M E M O R A N D U M

TO: Randy Fowler, Building Official
FROM: James Linkogle, Public Works Operations Manager
SUBJECT: CHANGE ORDER SUBMITTAL

Durante Park Restrooms

Permit # BP.15272

SECTION 1
 SCALE: 1/2" = 1'-0"

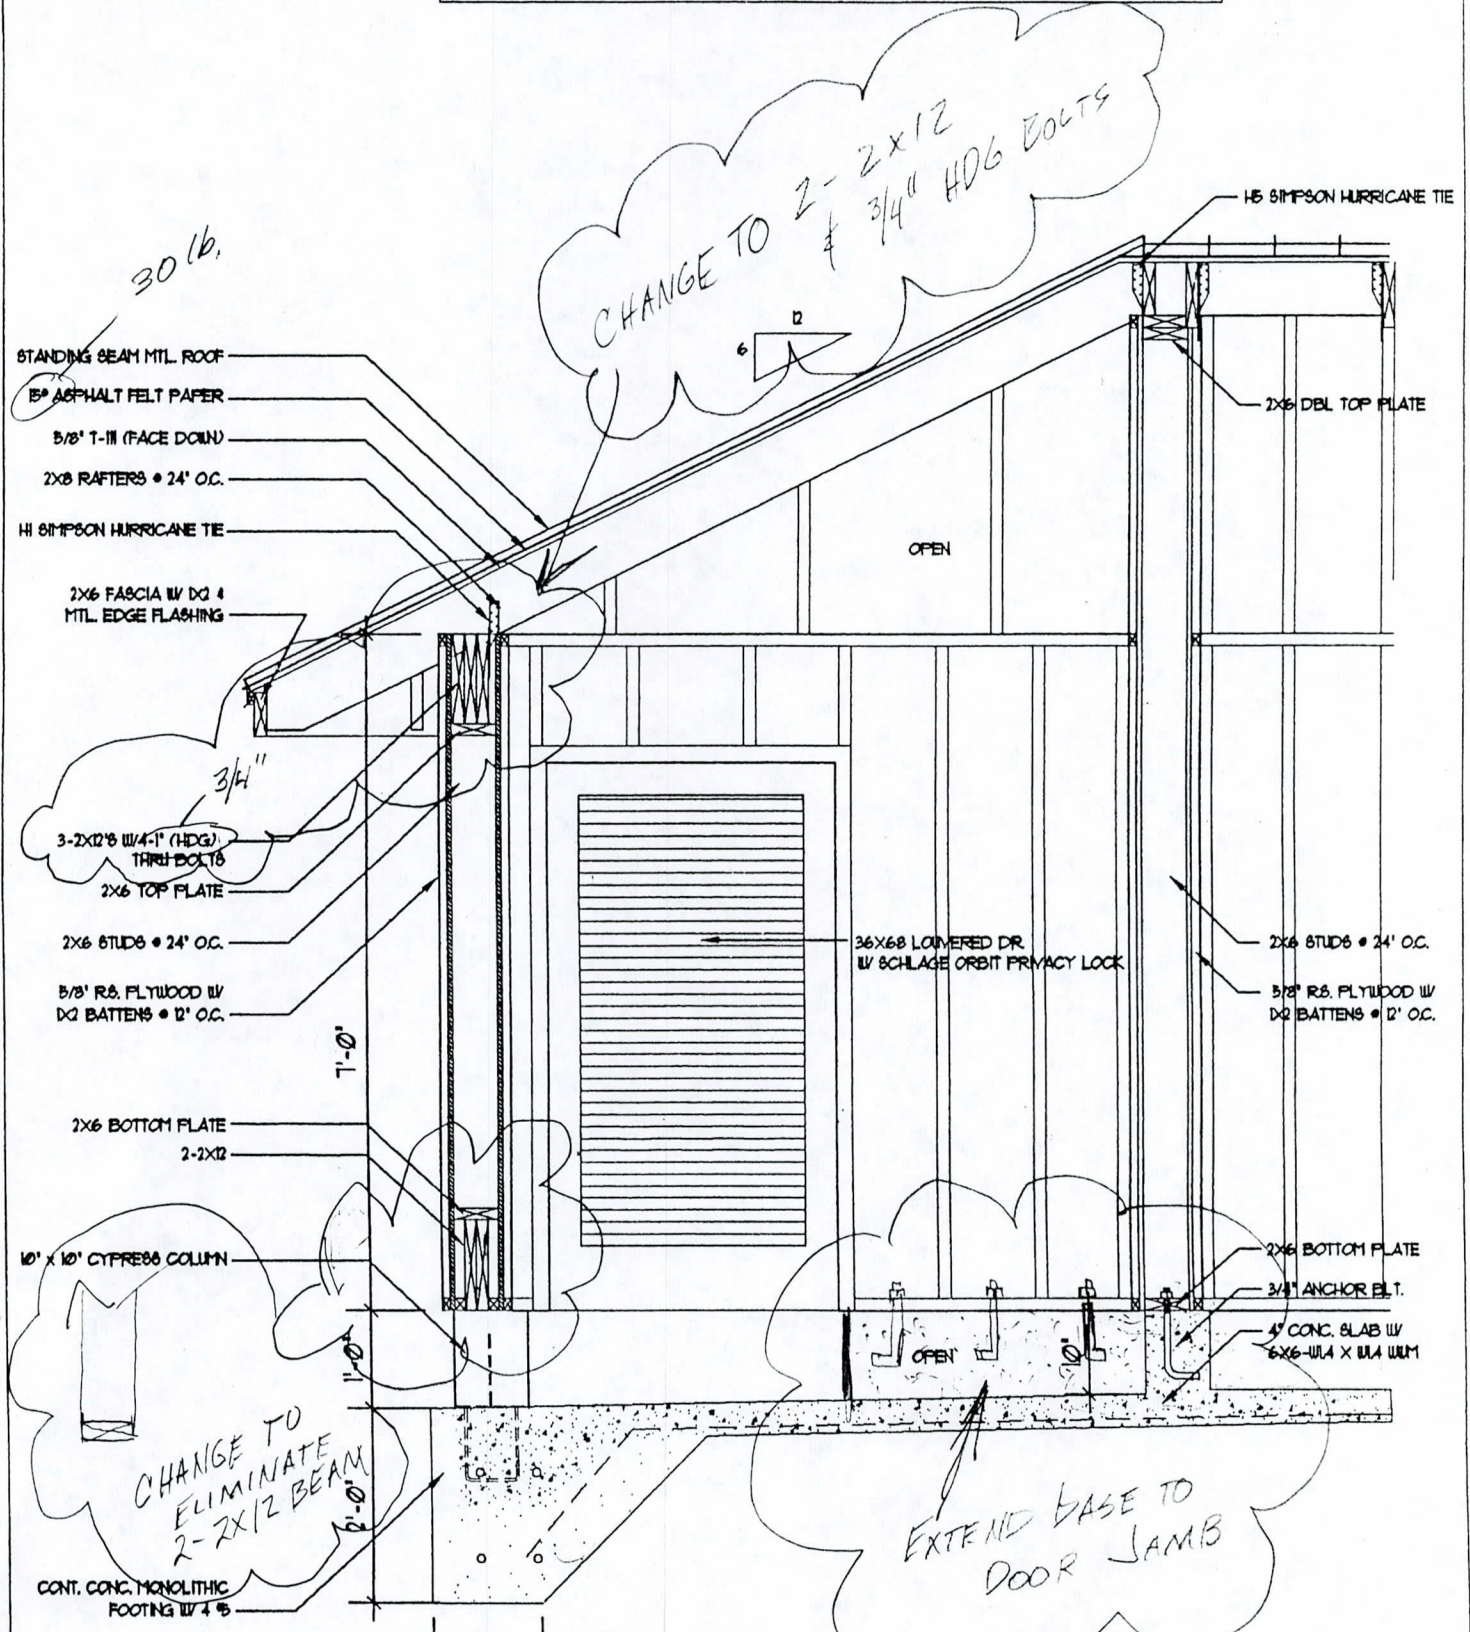
Note: Column post perimeter beam detail change.

- 1-Reduce from three to two, two by twelve members in beam.
- 2-Reduce bolt size from 1" HDG to ¾" HDG.
- 3-Eliminate double two by twelve beam at bottom of perimeter wall.
- 4-Extend concrete base wall to door jamb and add anchor bolts.
- 5-Increase roof felt to 30 lb.

Approved as per request
